## Memorandum

**Re:** **WBP Development LLC - 1 Croton Point (aka Lot A)**  
Jason Mencher, AICP (AKRF)

AKRF, Inc. has reviewed the following documents and plans for the above referenced application:

**Figure A-1  
Site Plan Comments - Traffic**

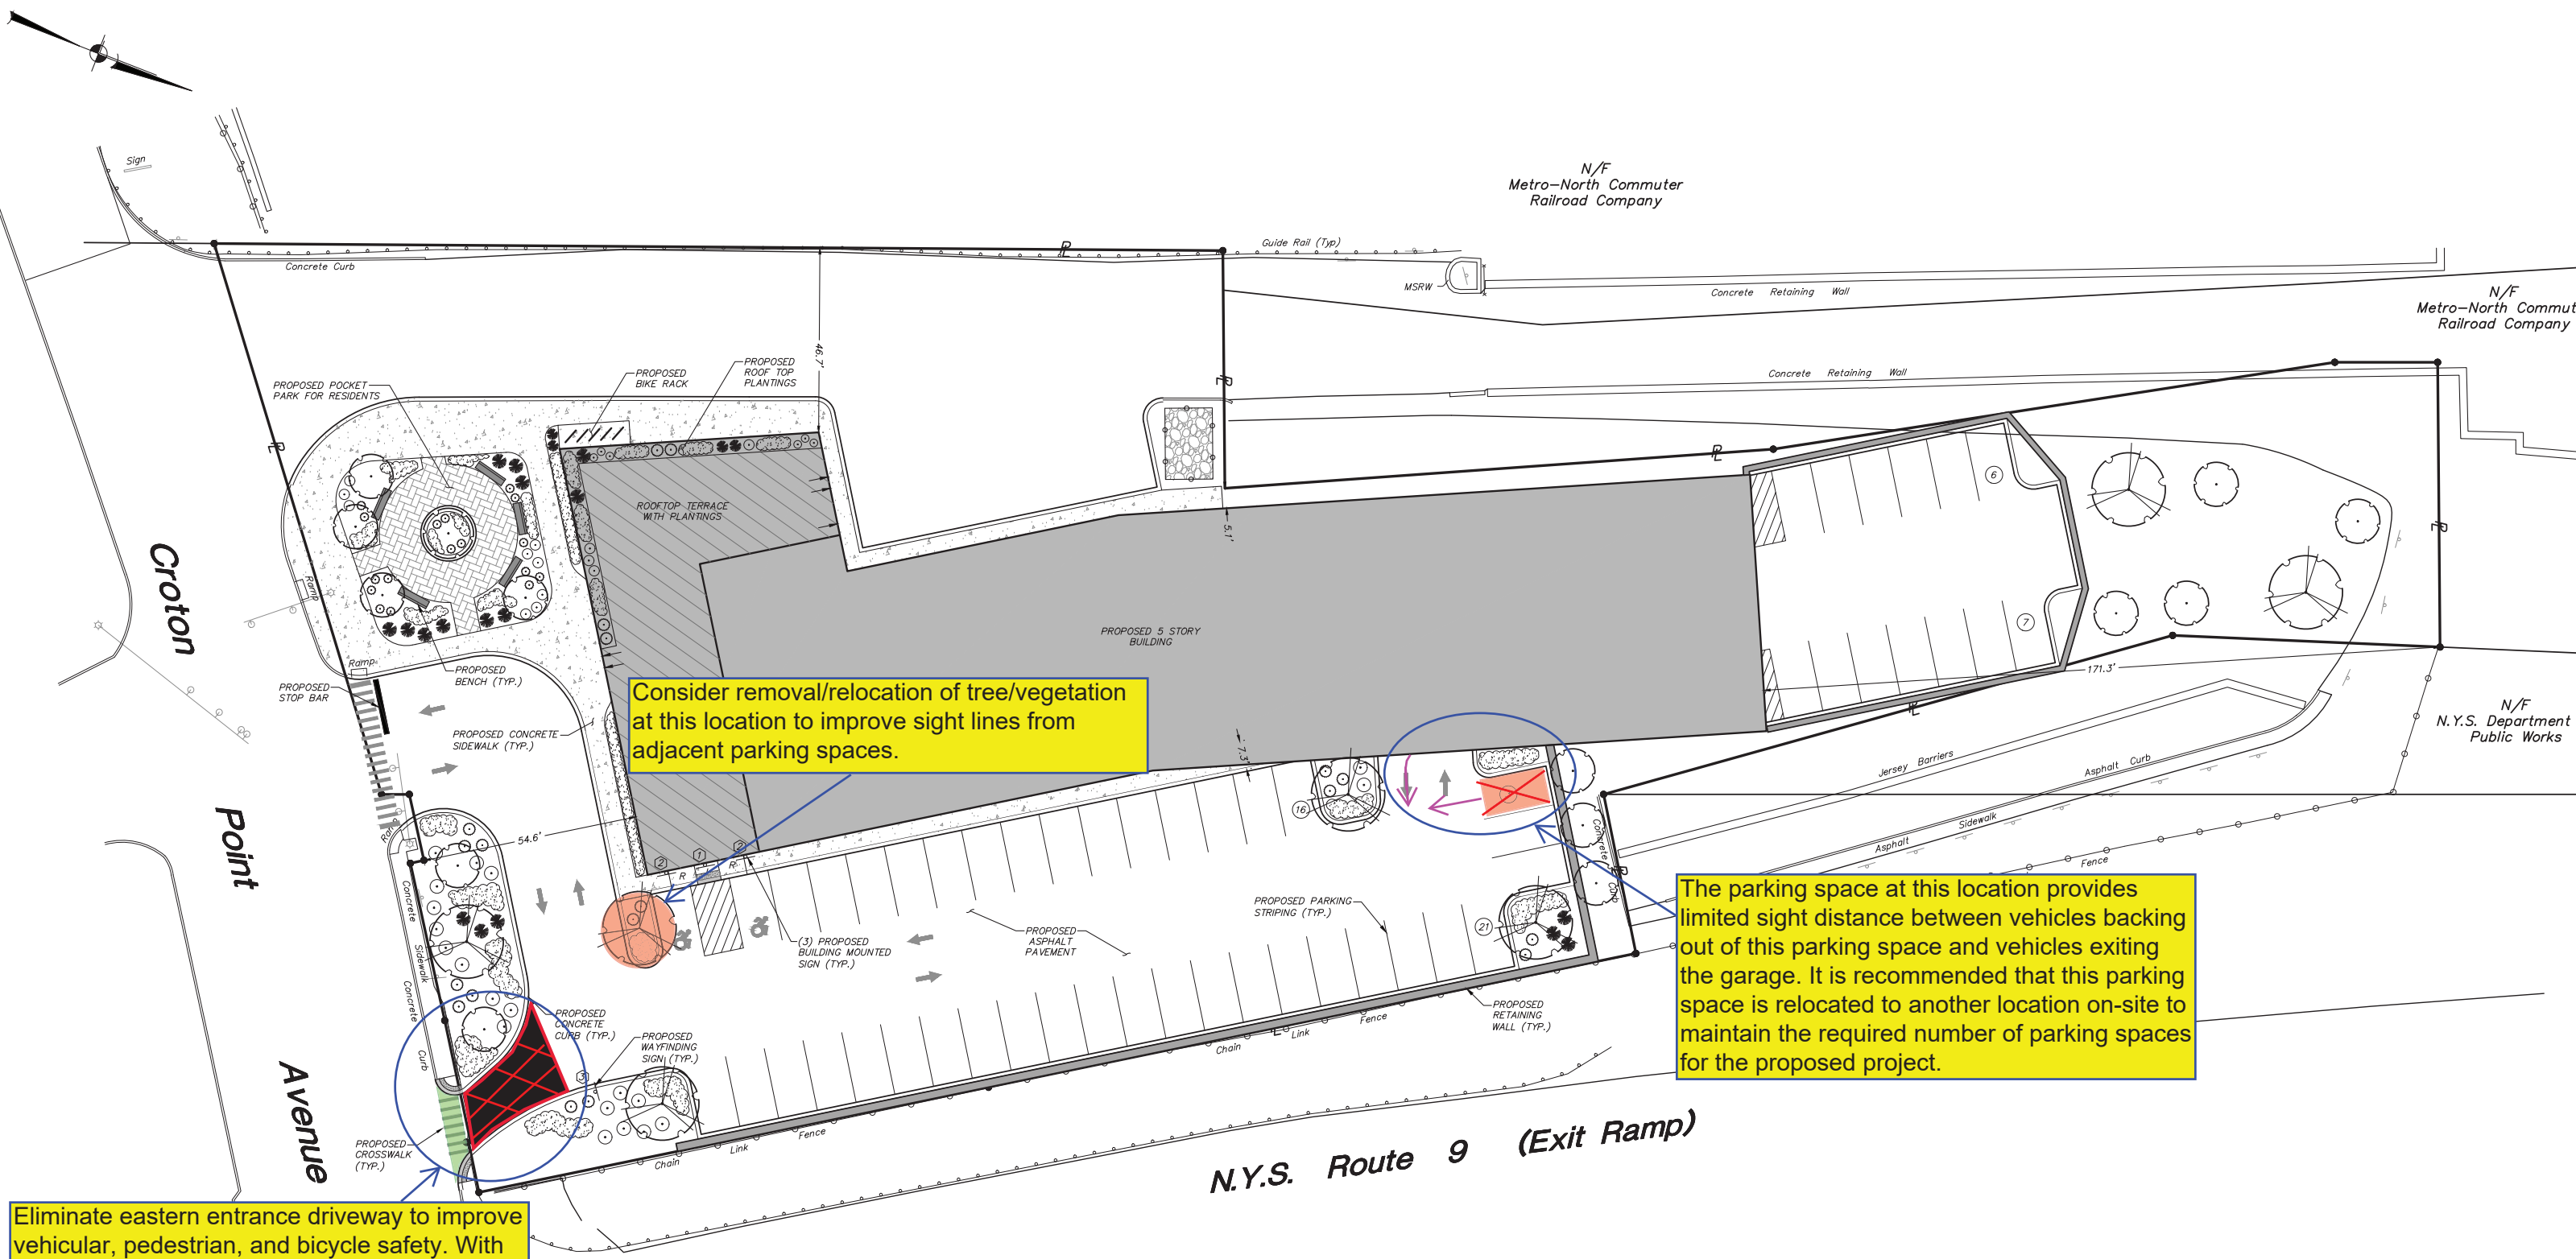
Consider removal/relocation of tree/vegetation at this location to improve sight lines from adjacent parking spaces.

The parking space at this location provides limited sight distance between vehicles backing out of this parking space and vehicles exiting the garage. It is recommended that this parking space is relocated to another location on-site to maintain the required number of parking spaces for the proposed project.

Eliminate eastern entrance driveway to improve vehicular, pedestrian, and bicycle safety. With this removal, the sidewalk and bike lane along Croton Point Avenue can remain contiguous and a crosswalk would no longer be necessary.
